Staff Report to the Western Weber Planning Commission

Application Request:	Consideration and action on a request for preliminary plan approval of Staker Farmstead Estates Cluster Subdivision.
Type of Decision:	Administrative
Agenda Date:	Tuesday, May 09, 2017
Applicant:	E. Hal Christensen, Applicant; Val and Linda Staker, Owners
File Number:	LVS040417

STAKER FARMSTEAD ESTATES RESIDENTIAL CLUSTER SUBDIVISION TAYLOR, WEBER COUNTY, UTAH

Exhibit A

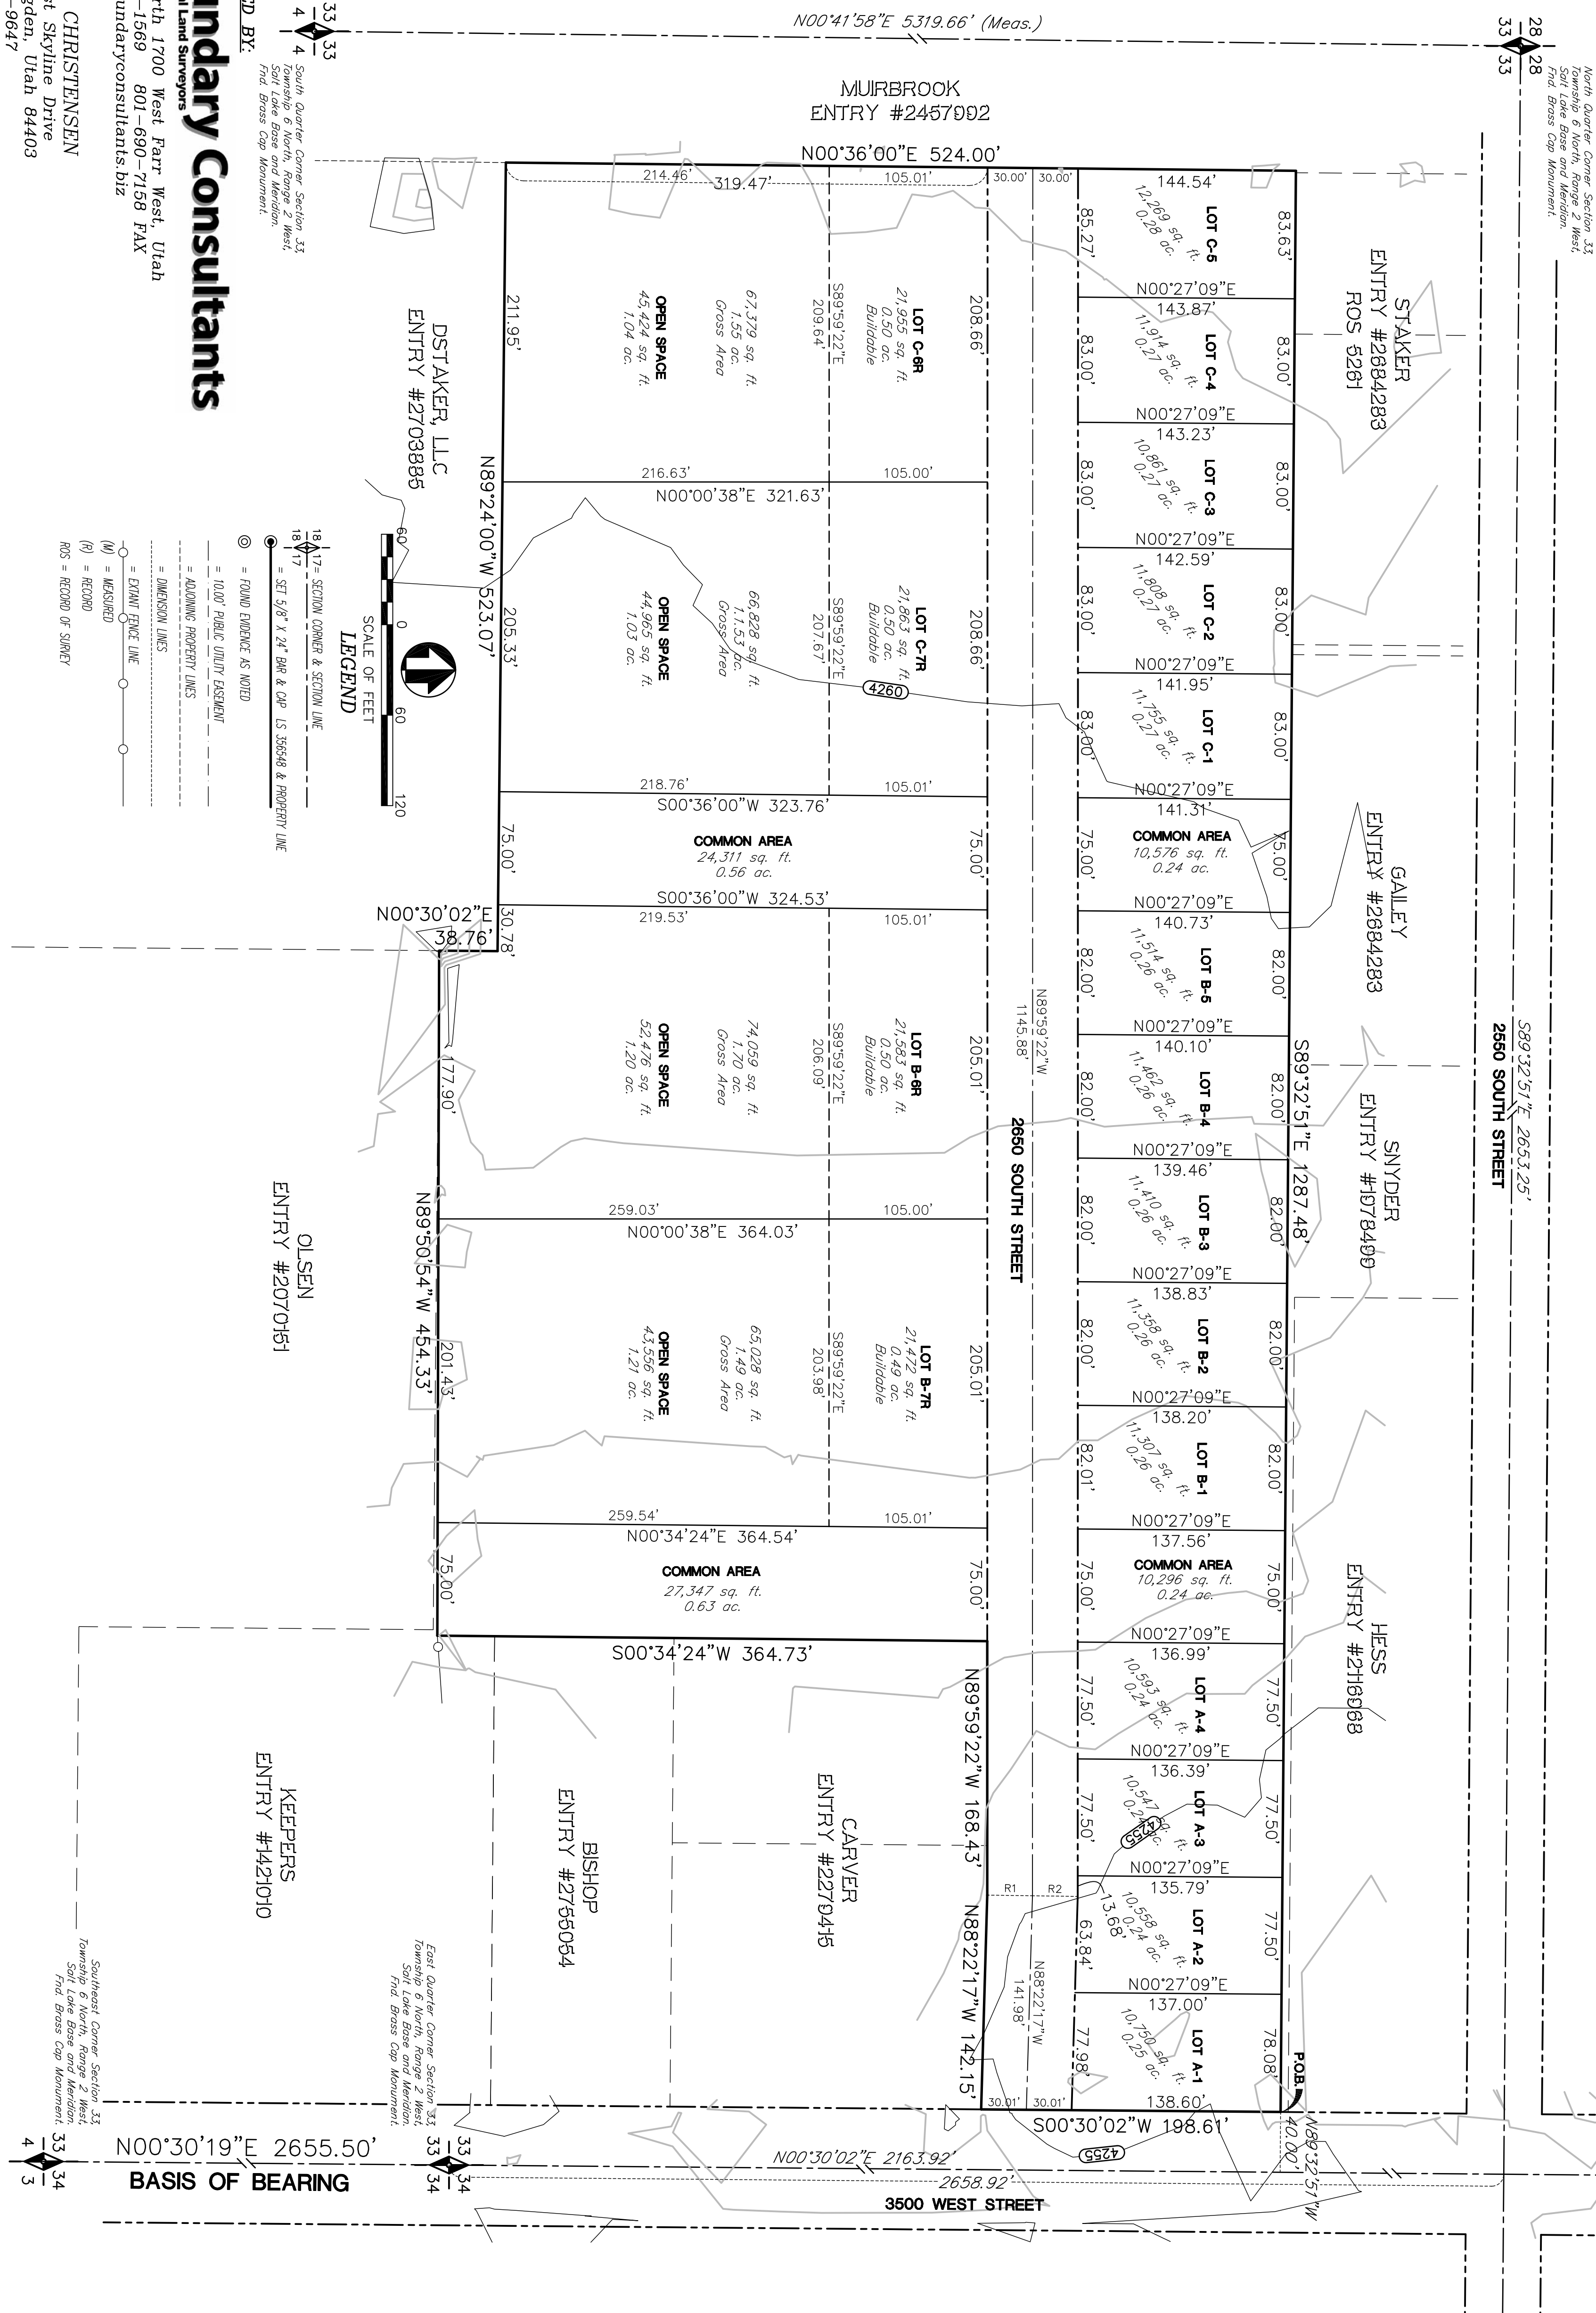
The applicant has proposed to implement walking trails consisting of sidewalks within the common area strips located between clusters of lots. A condition of approval has been added to the staff recommendation to show the exact location of the proposed trails within the common areas between clusters.

3. A guarantee of Improvements will be required as outlined in LUC § 106-4-3.
4. The applicant must label 'Open Space Parcel 3' and 'Open Space Parcel 4' as common area to be owned by the homeowners association as outlined in LUC §108-3-6 (1) (b).

5. The applicant must provide a site plan for the proposed sidewalk trails within the common areas prior to receiving final approval from the Planning Commission.

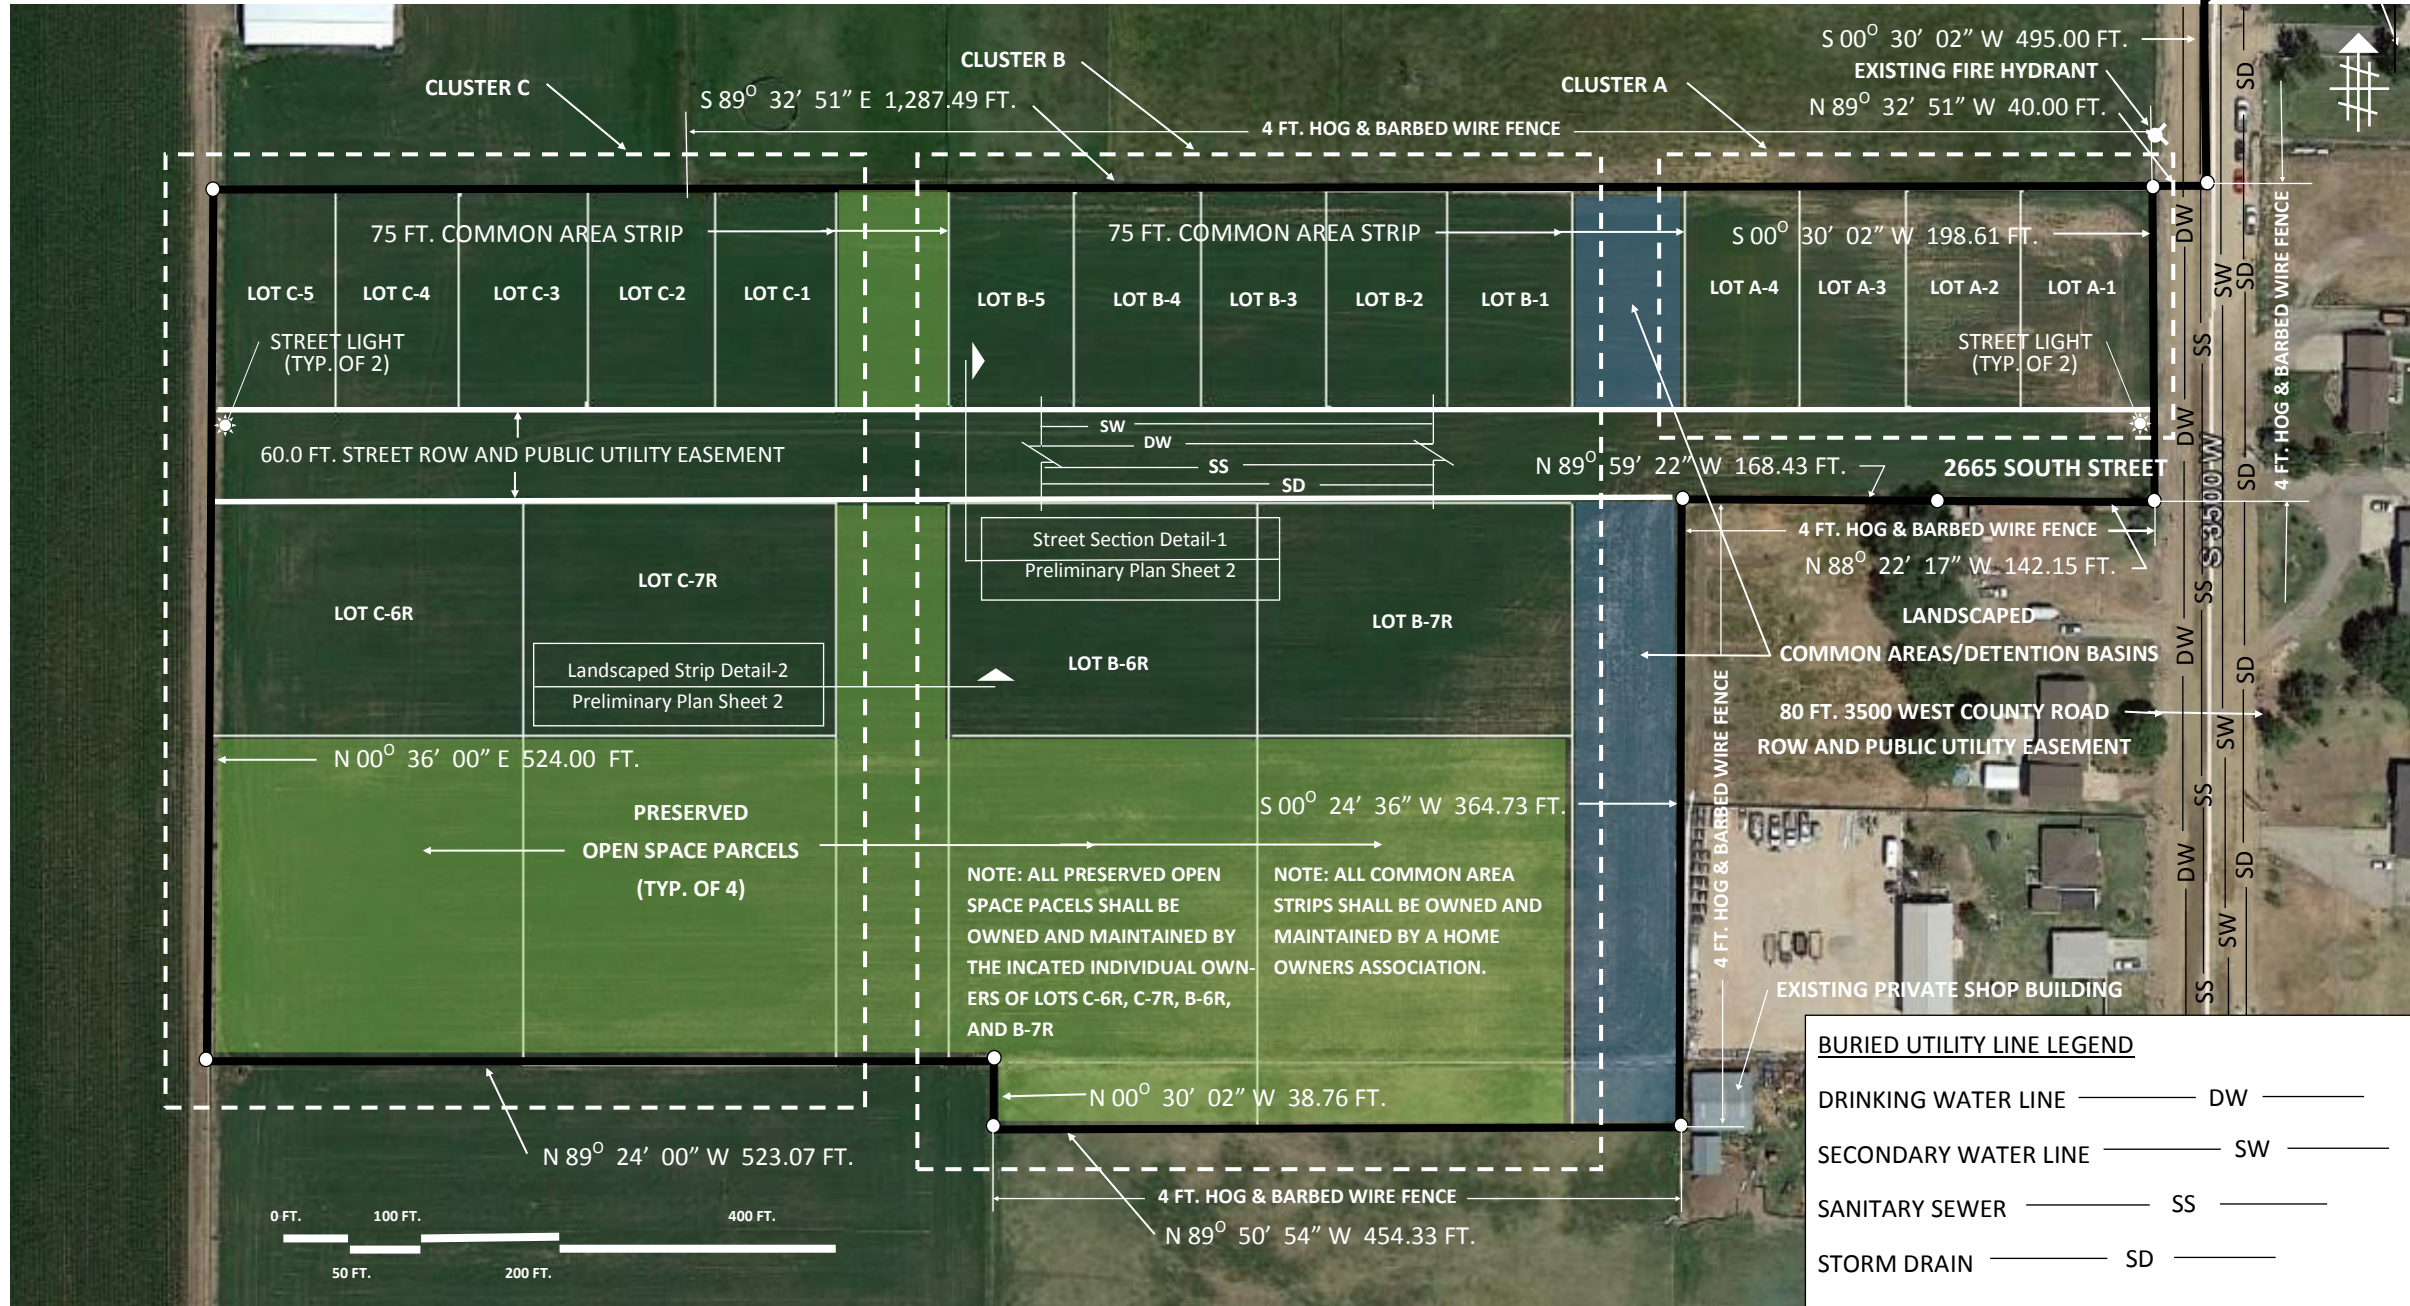
The applicant has proposed three clusters within the subdivision. Two of the three clusters consist of seven lots, which exceeds the one-third design requirement as outlined in LUC§ 108-3-4(2) which states:

The applicant is requesting the County to increase the number of lots in the two clusters to seven lots instead of six. This request is allowed per LUC§108-3-4(2)(a)&(b) which states:

In order to allow for the maximum amount of lots in the A-1 zone and with up to a 50% bonus density in the cluster subdivision, the applicant is requesting the flexibility within the two clusters due to the open space design criteria in the cluster subdivision code and the current parcel configuration.

The proposed lot sizes vary from 10,547 square feet to 29,009 square feet. The minimum lot size can be reduced below 15,000 square feet based on meeting the criteria outlined in LUC§108-3-7 which states:

The proposed cluster subdivision is adjacent to multiple undeveloped parcels to the north and south of the current parcel's boundaries, meeting the requirement to reduce lot size to 6,000 square feet. All lots within the proposed cluster subdivision meet the area and width requirements.
